Change Order

Edward Devotion School Project
Town of Brookline
333 Washington Street
Brookline, MA 02245

CHANGE ORDER NUMBER: 016

(Include, where applicable, any undisputed amount attributable to previously executed Construction Change Directives)
CR009 Fill Voids Under 1913 Building SOG \$5,865; CR089 PR #15R1 - Extended Slab at K-2 Wall Footing \$3,398; CR093
PR #73 - LGMF Back-up Wall in Large Gym \$20,542; CR117 PR #85 - Shadow Box at CW28 and Added Gyp Soffit \$2,388;
CR131 Replacement of Bird Screens at Cupola per HMFH Field Report \$966; CR136 RFI #368 - Added Wall in MDF 109
\$2,434

RFI #158

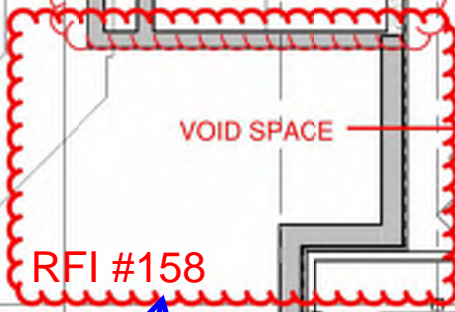
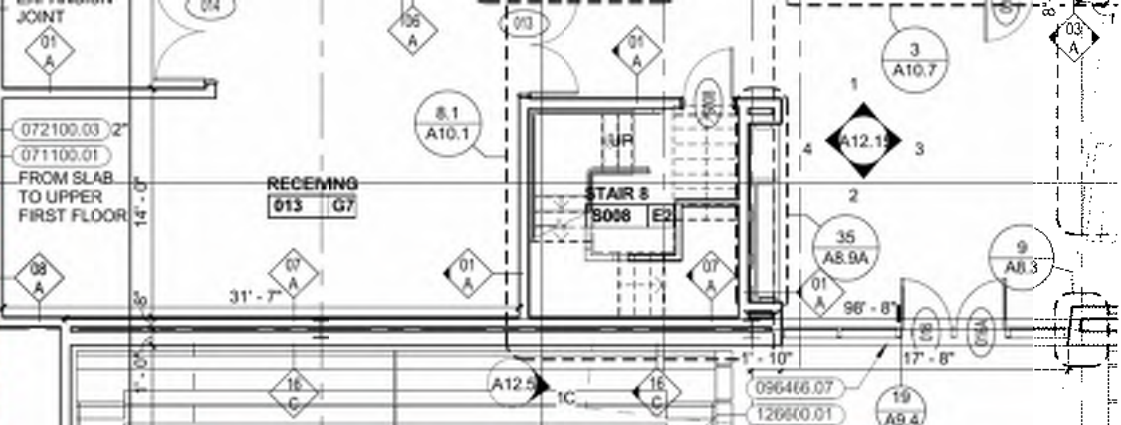
VOID SPACE

<b>Proposal Request (PR)</b>		NO: <b>015 R1</b>
Date of Issuance:	<del>January 3, 2017</del> Revised: March 20, 2017

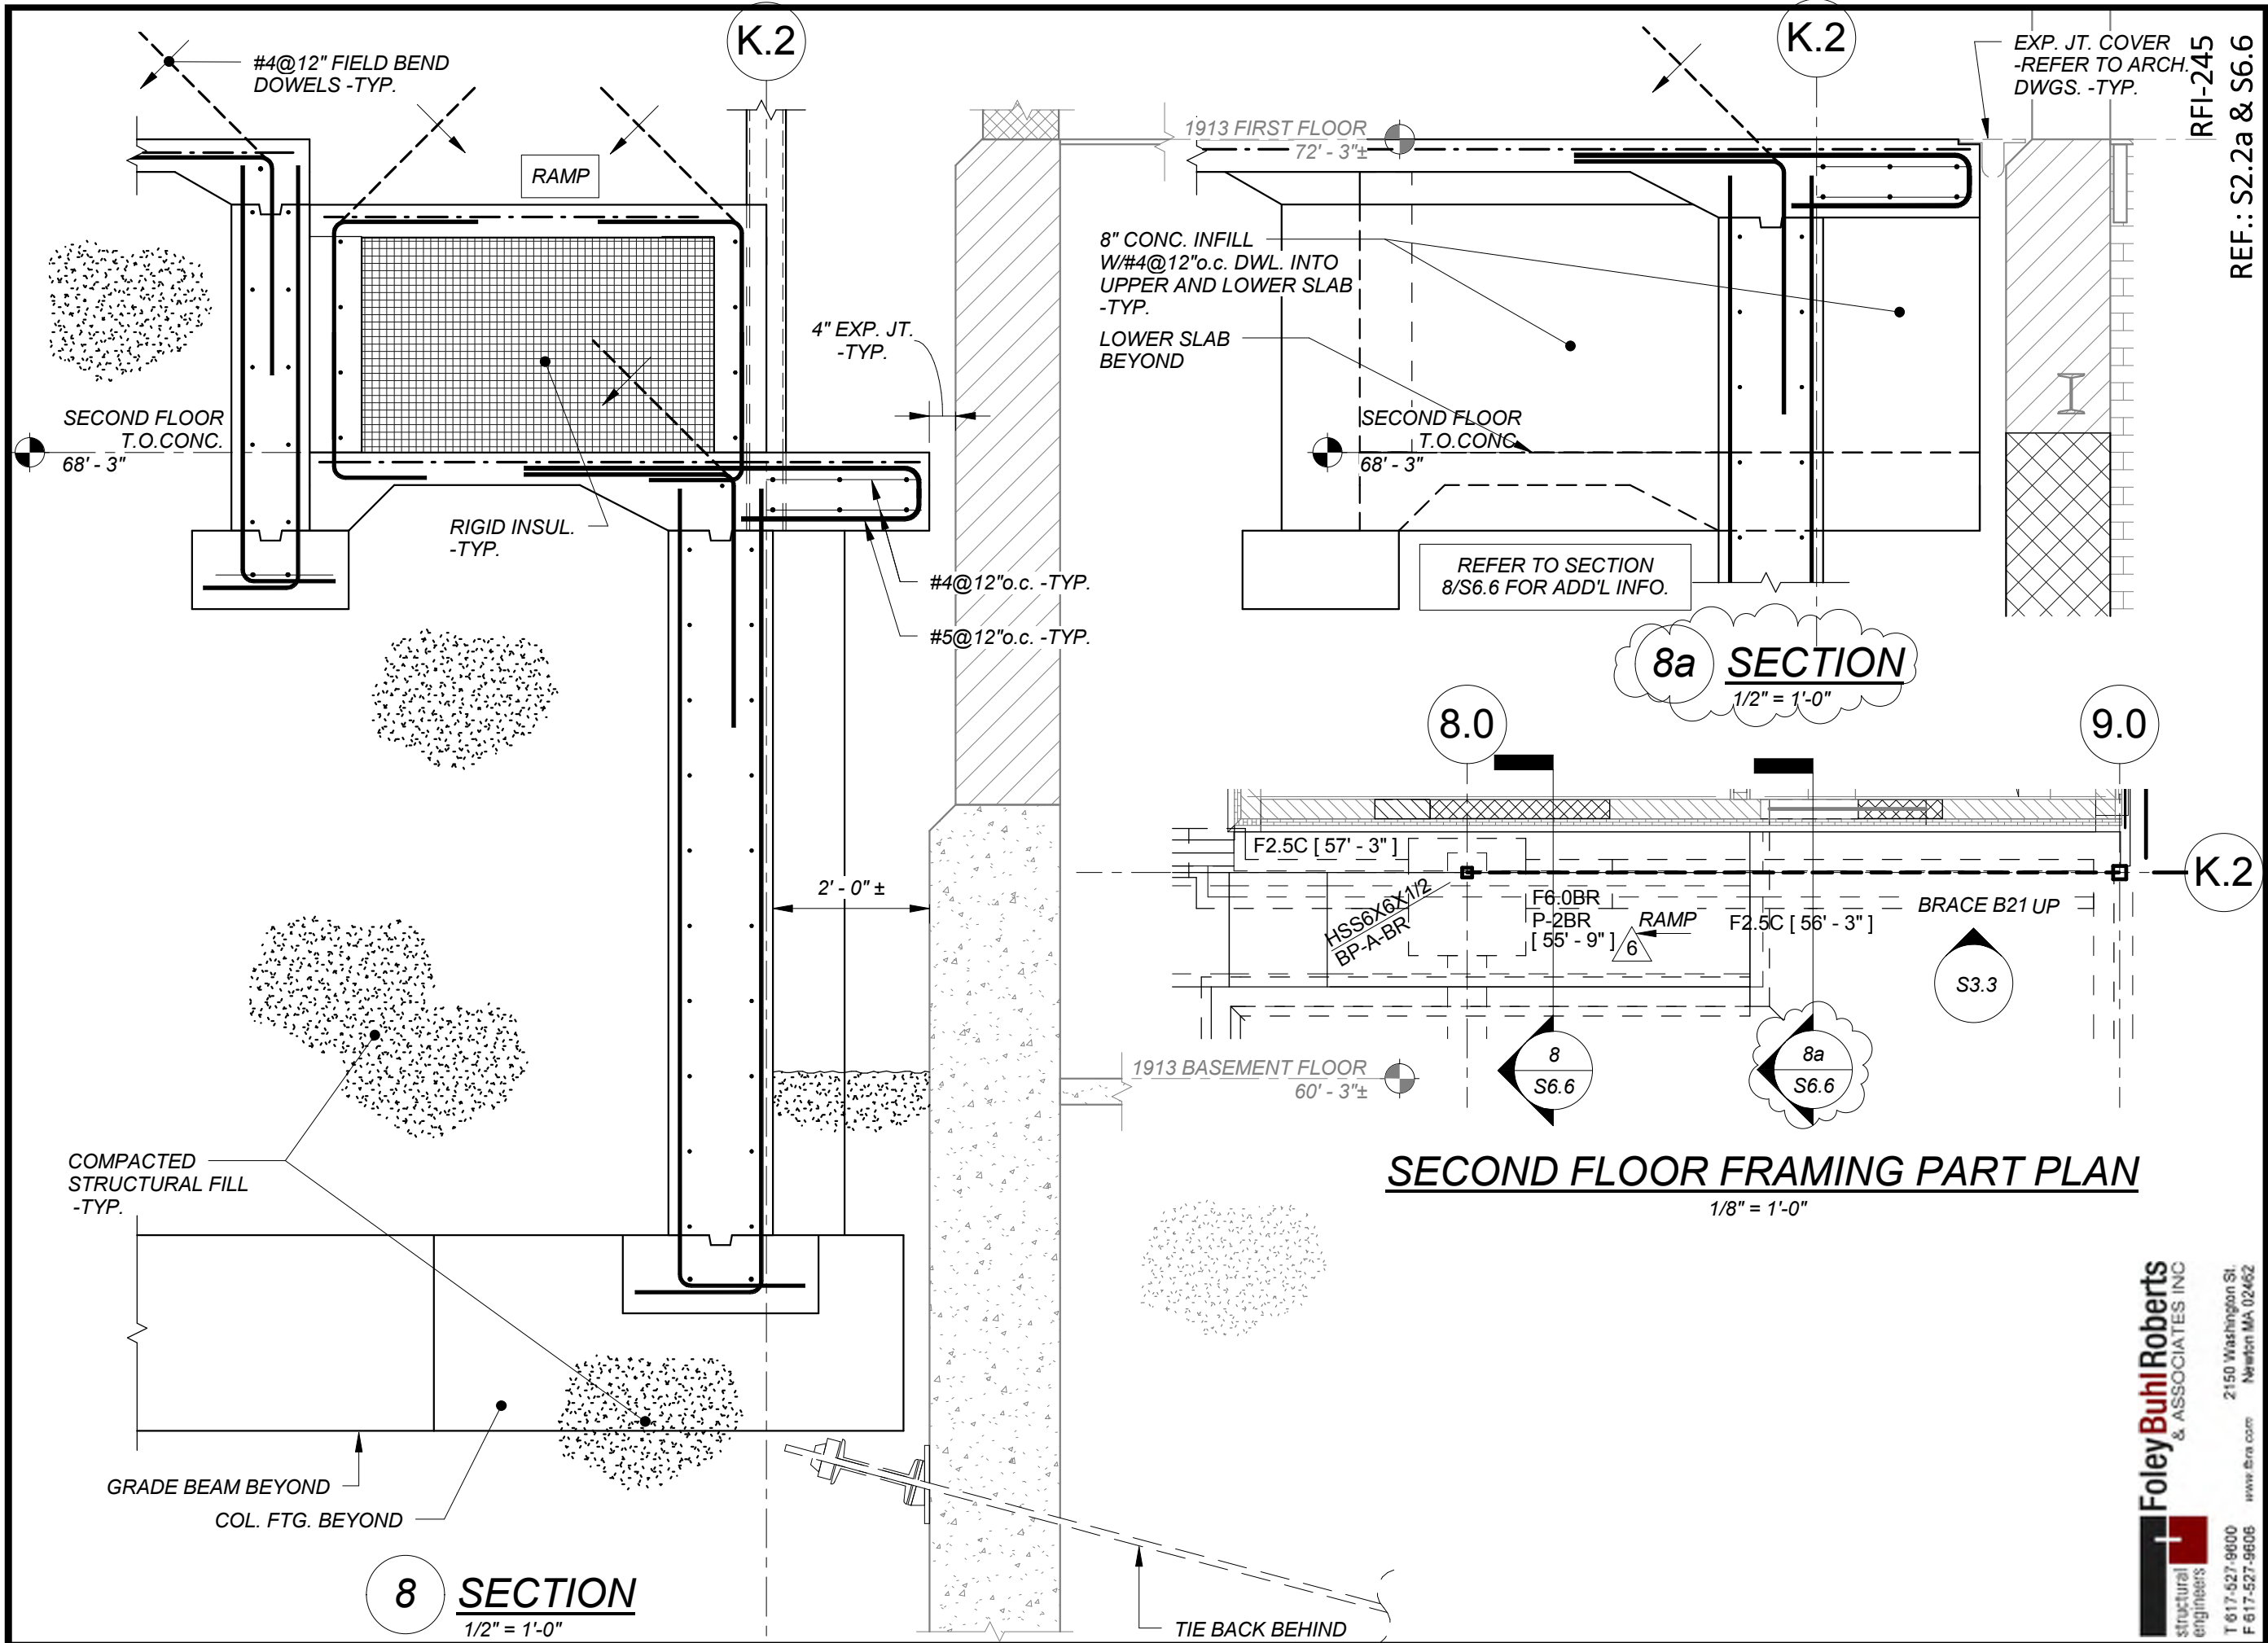
Refer to attached SKS-121: Provide a credit to raise the footing between 8.0 and 9.0 as shown. Provide a cost to extend the slab out toward the existing building as shown.

Revised March 20, 2017:  
Refer to attached SKS-121 R1: Add section 8A at the upper second floor showing the slab extension required to connect to the existing 1913 building second floor. This change is a result of RFI#245. There is not a cost anticipated with this change.

**PLEASE NOTE: FOOTING DEPTH CHANGED SLIGHTLY IN A FILL AREA FROM 55'-2 1/2" TO 56'-3". THERE IS NO CHANGE IN EXCAVATION WORK AND NO CREDIT TO RAISE THE FOOTING.**

DRAWING NUMBER  
**SKS**  
**121R1**  
JOB NUMBER  
401213

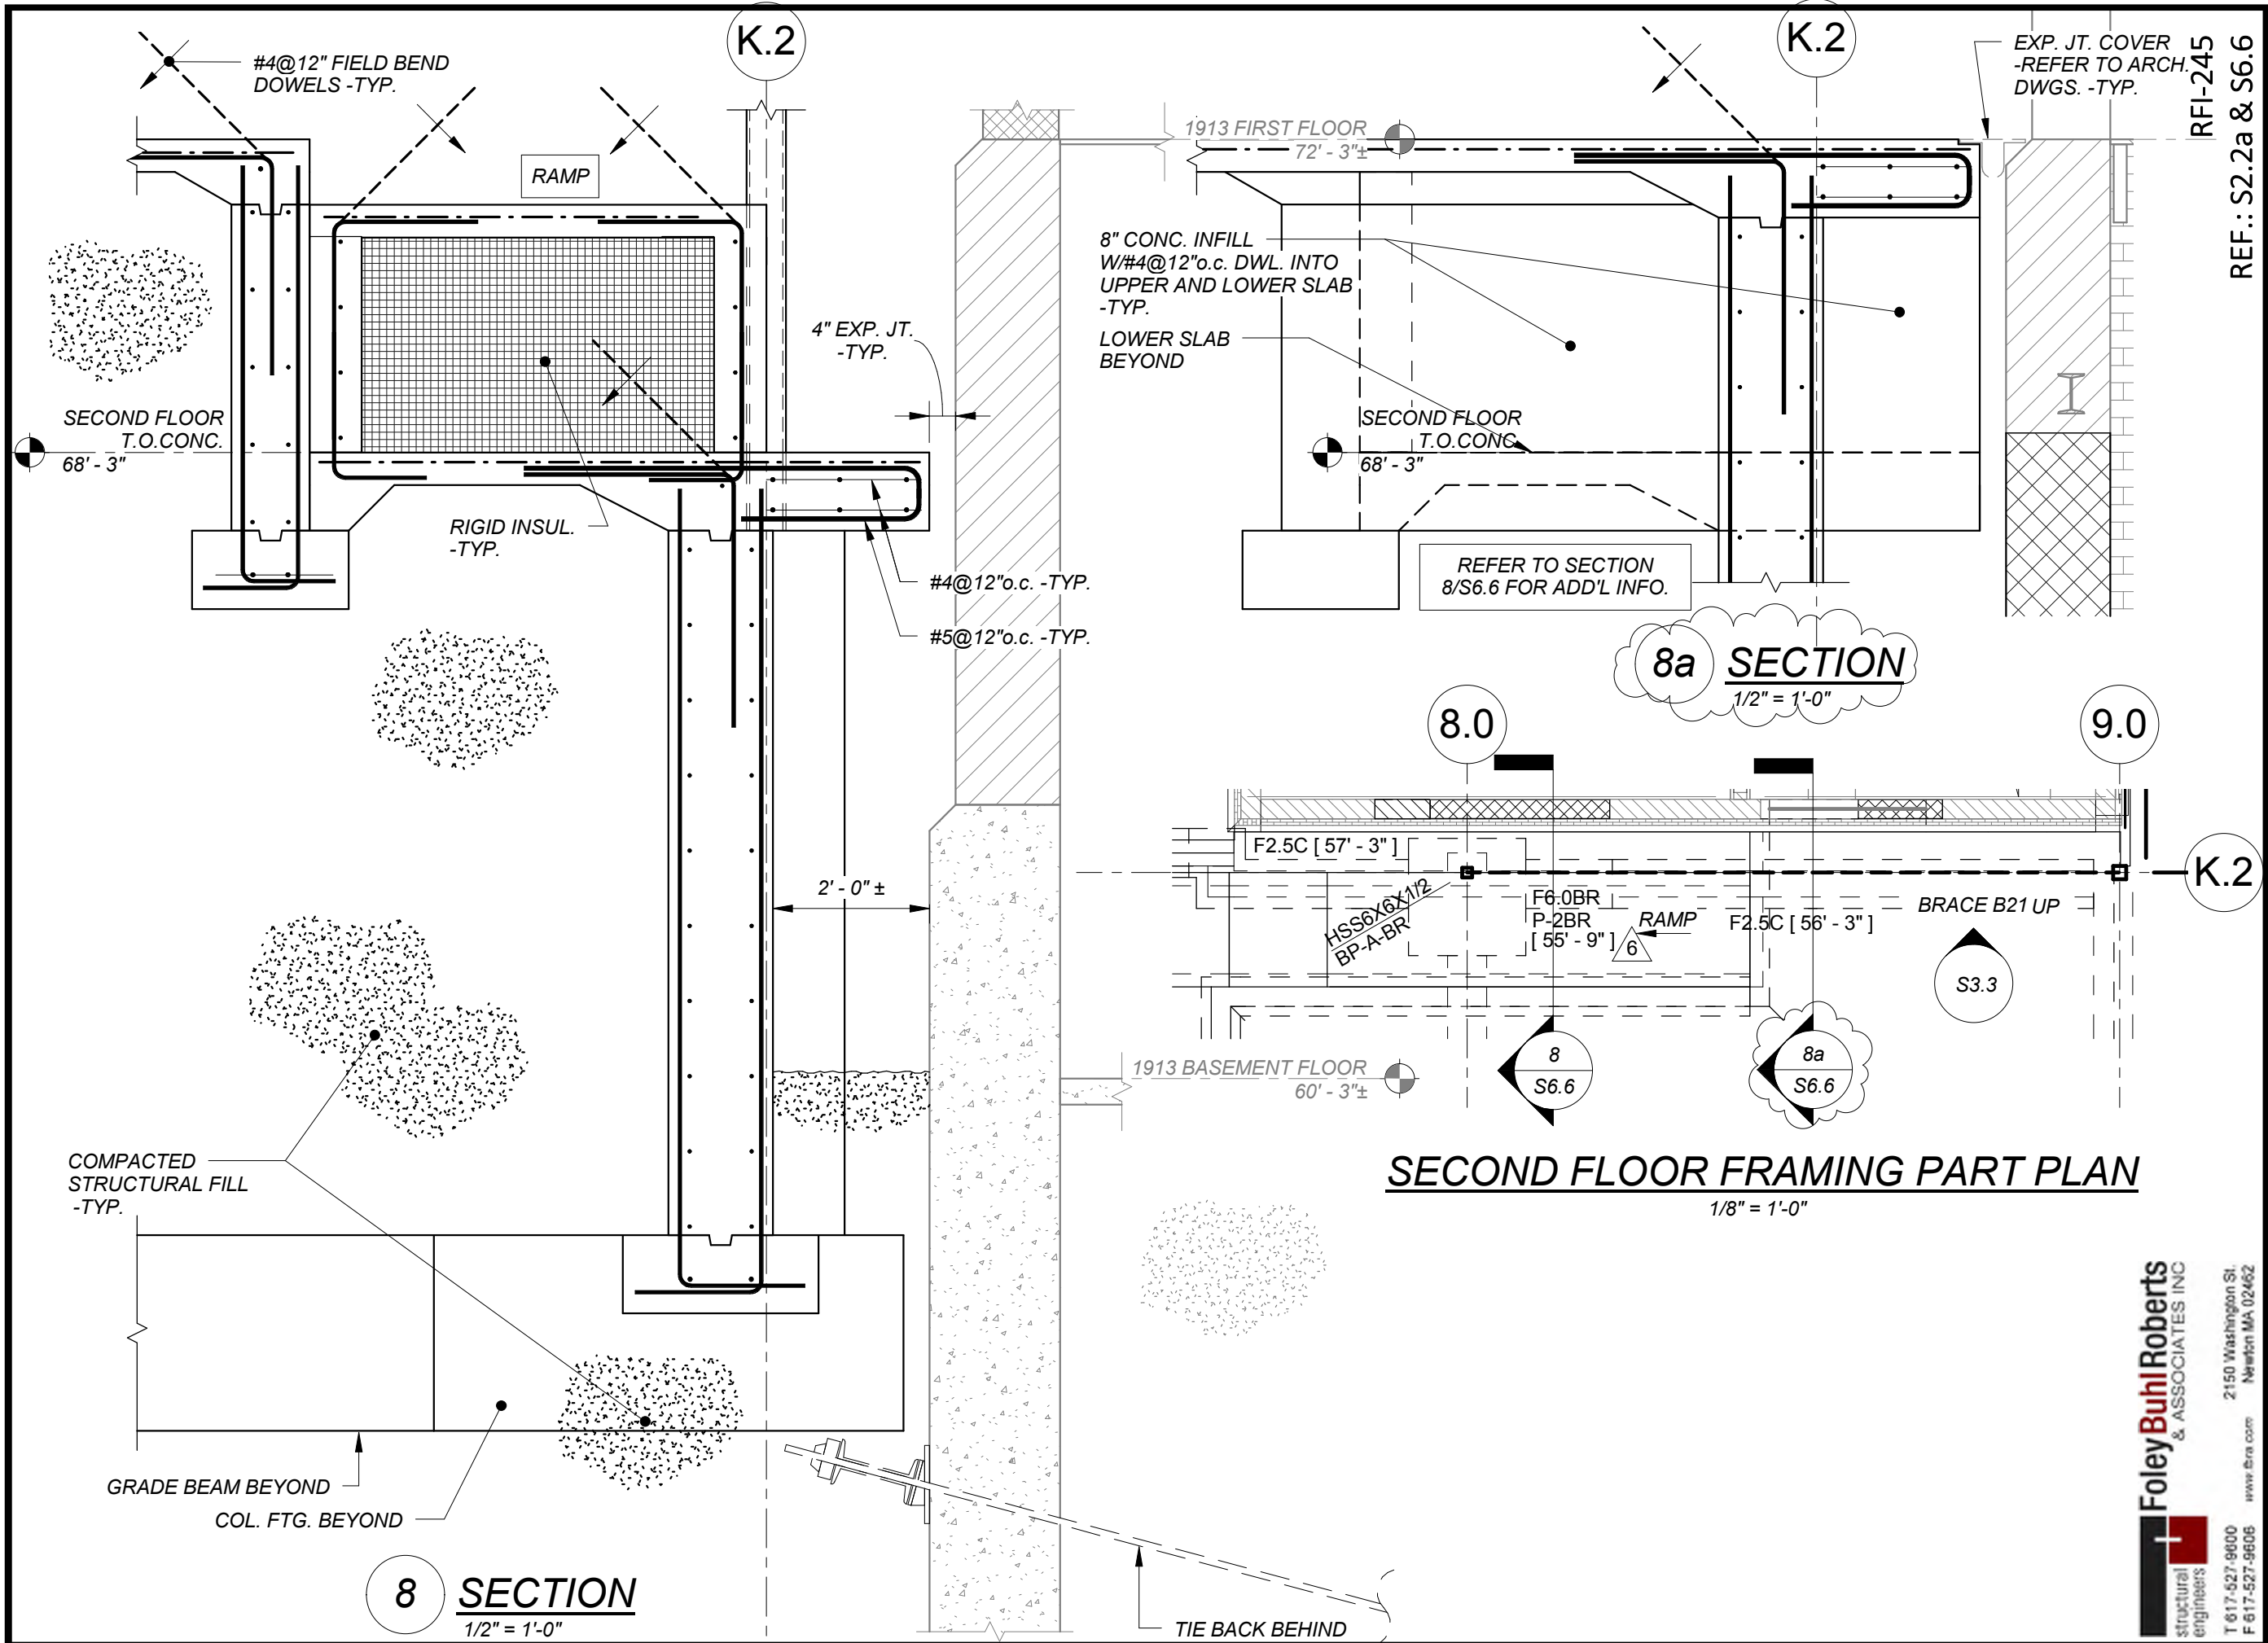
Refer to previous RFI #118.  
Per response to RFI #118, the new K.2 wall was moved 2' from the 1913 building. A structural slab "extension" was included at the 2nd floor (EL. 68'-3"), shown on SKS-121, but was not added at the high 2nd floor (EL. 71'-8 1/2"). Please provide a detail/section cut for an additional structural slab "extension" from the K.2 wall to the 1913 building doorway at the high 2nd floor. Please note that the structural slab is only needed for the doorway, and not all the way to 9 Line.  
The previous response to RFI #118 is attached for reference, with added notes in BROWN.

Refer to attached response from FBRA. The revised SKS121R1 will be issued with a revision to Proposal Request 015.
